Access Compliance Report Public Rights-of-Way (Curb Ramps)

Main Street: WEMBLEY_RD Cross Street: CHESNEY_DR Location: SE

ADA ID: RPAT211201090858 Ramp Type: Type 1 - Perpendicular Diagonal Initial Pass/Fail: Pass Overall Compliance: No Severity Score: 16

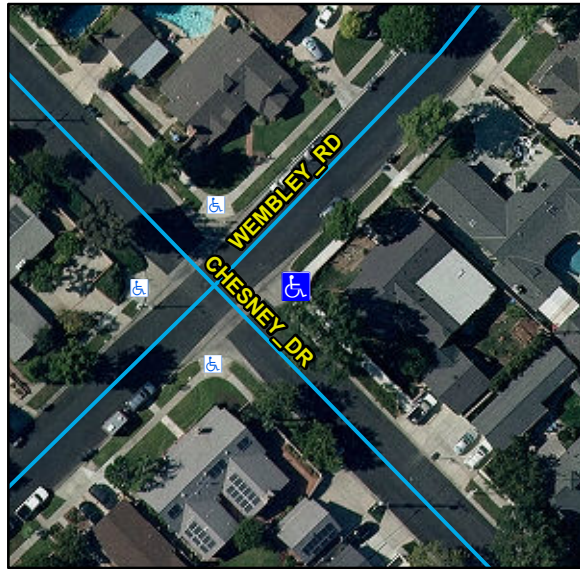
R304.2.2, R204.3, R304.2.1, R304.2.2-Perp, R304.3.2-Para, R305, STD 1115

Remove & Replace Curb Ramp With Two New Directional Ramps or Equivalent.
